## **MUKILTEO FERRY TERMINAL (PHASE 2) FERRY TERMINAL CONSTRUCTION**

VOLUME 2 OF 8

VOLUME 2 SHEET INDEX

SR 525	C10.15
MUKILTEO FERRY TERMINAL (PHASE 2)	SHEET
FERRY TERMINAL CONSTRUCTION	257
	OF
PAVING PLAN	1521
	SHEETS

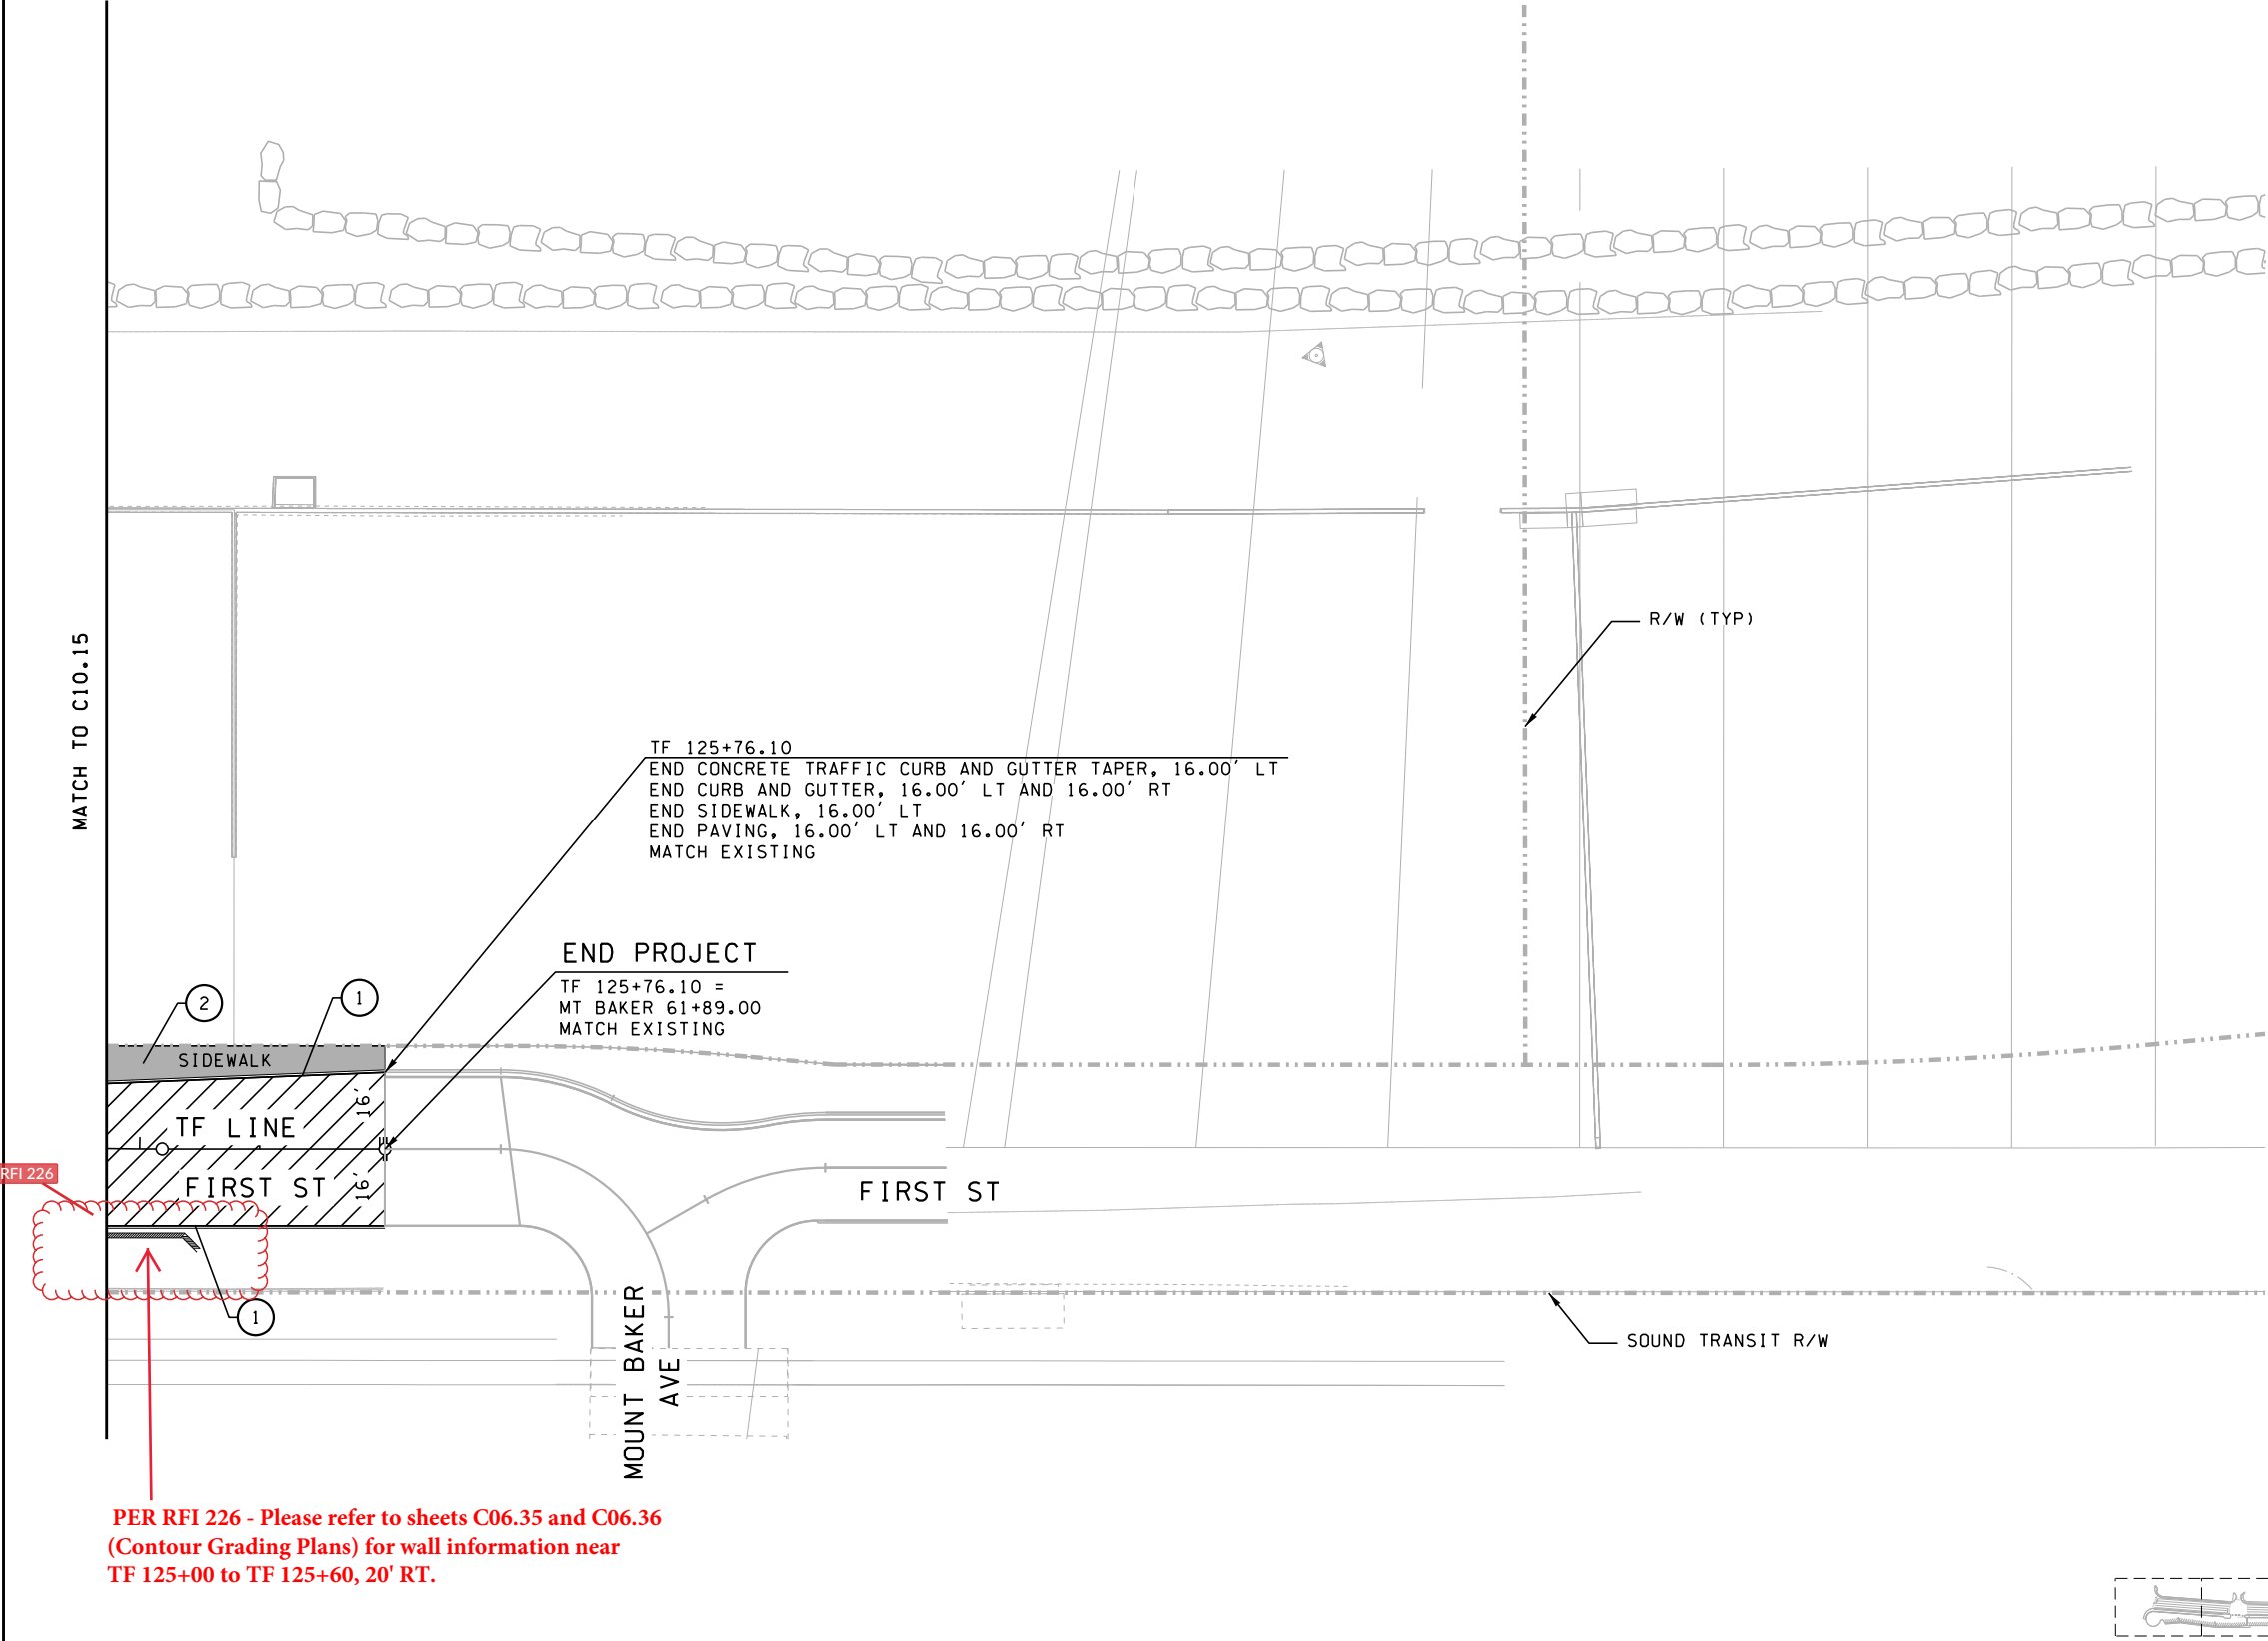
PER RFI 226 - Please refer to sheets C06.35 and C06.36 (Contour Grading Plans) for wall information near TF 125+00 to TF 125+60, 20' RT.

C10.16

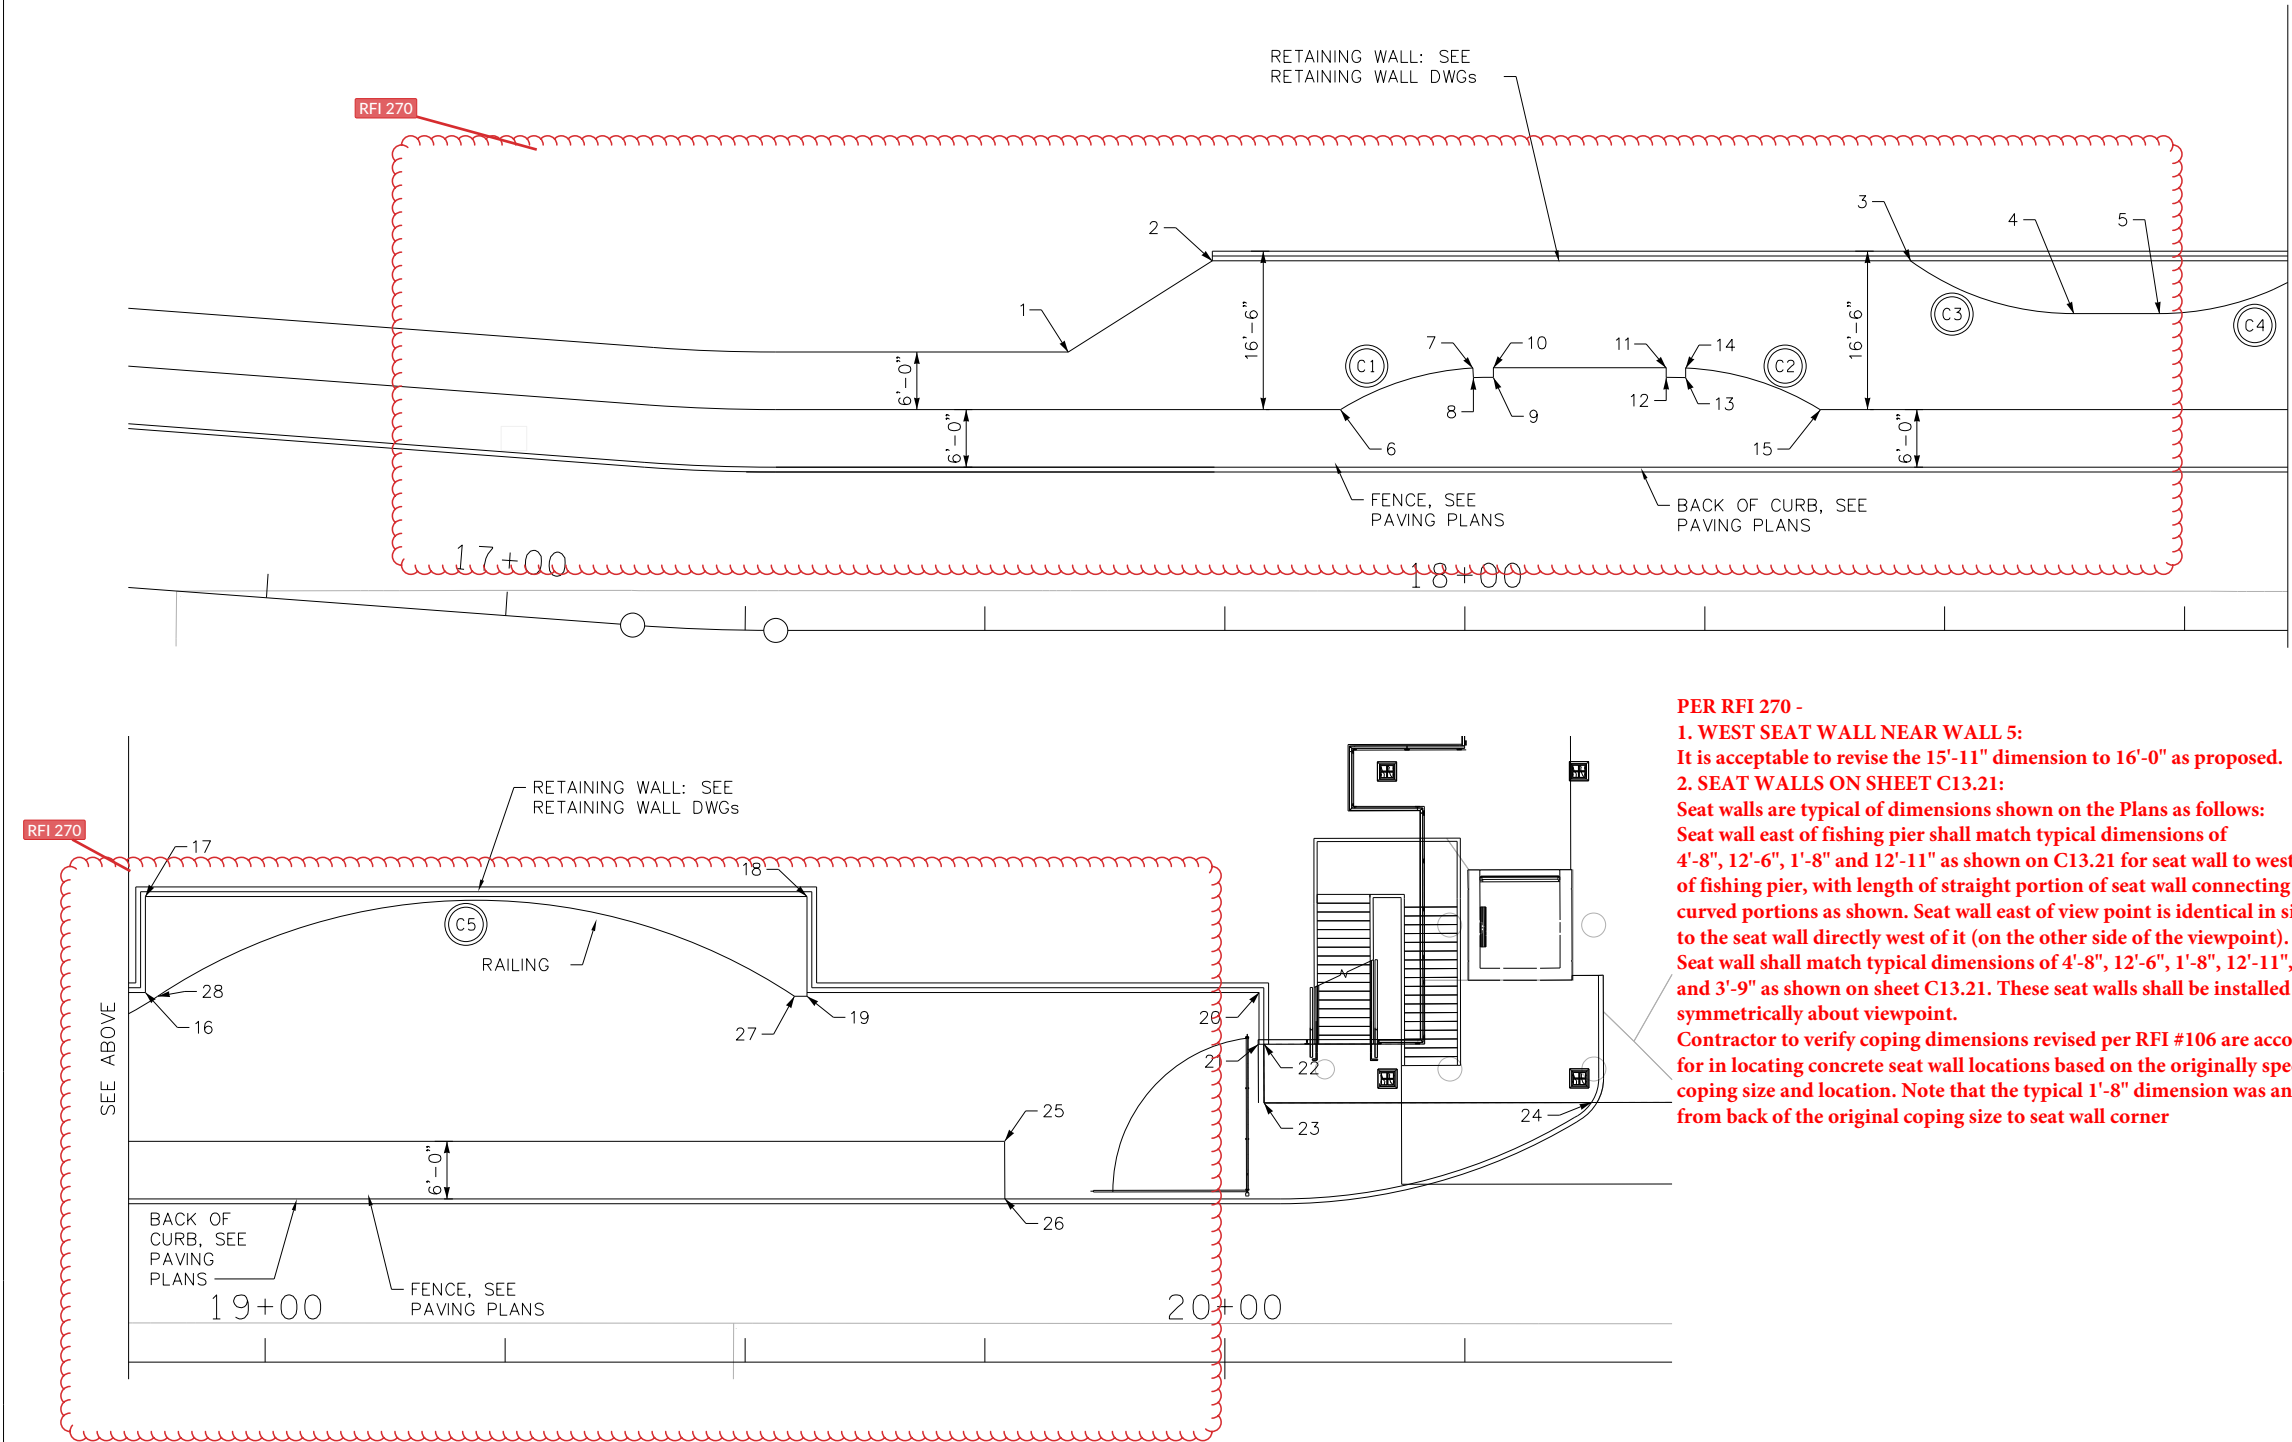
**PER RFI 270 -**  
**1. WEST SEAT WALL NEAR WALL 5:**  
It is acceptable to revise the 15'-11" dimension to 16'-0" as proposed.  
**2. SEAT WALLS ON SHEET C13.21:**  
Seat walls are typical of dimensions shown on the Plans as follows:  
Seat wall east of fishing pier shall match typical dimensions of 4'-8", 12'-6", 1'-8" and 12'-11" as shown on C13.21 for seat wall to west of fishing pier, with length of straight portion of seat wall connecting curved portions as shown. Seat wall east of view point is identical in size to the seat wall directly west of it (on the other side of the viewpoint). Seat wall shall match typical dimensions of 4'-8", 12'-6", 1'-8", 12'-11", and 3'-9" as shown on sheet C13.21. These seat walls shall be installed symmetrically about viewpoint.  
Contractor to verify coping dimensions revised per RFI #106 are accommodated for in locating concrete seat wall locations based on the originally specified coping size and location. Note that the typical 1'-8" dimension was an offset from back of the original coping size to seat wall corner

### RETAINING WALL 4 PLAN

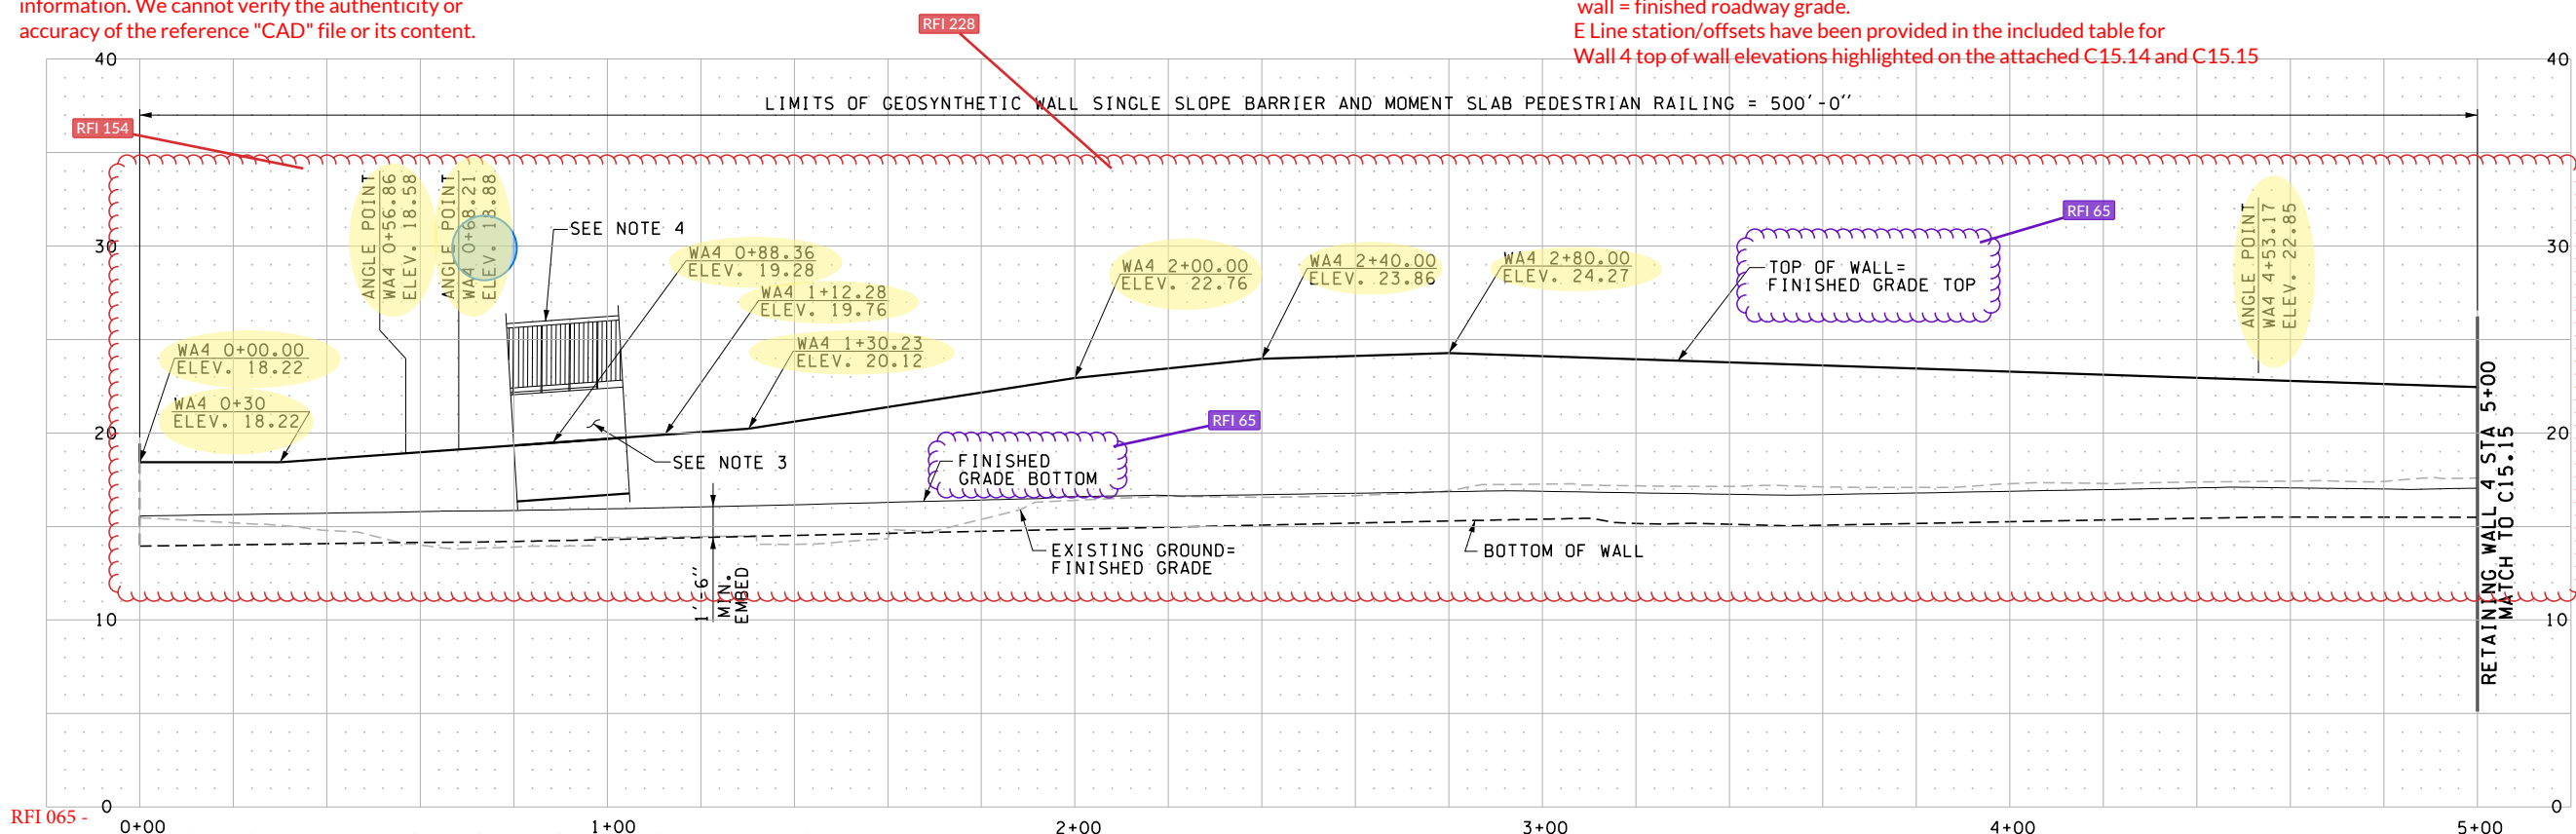
Per RFI 228 - RFI065 response confirmed top of wall elevations for Wall 4 = finish grade top. RFI154 response confirmed top of wall elevations for Wall 4 provided in the Contract Plans were correct. Wall 4 top of wall = finished roadway grade. E Line station/offsets have been provided in the included table for Wall 4 top of wall elevations highlighted on the attached C15.14 and C15.15
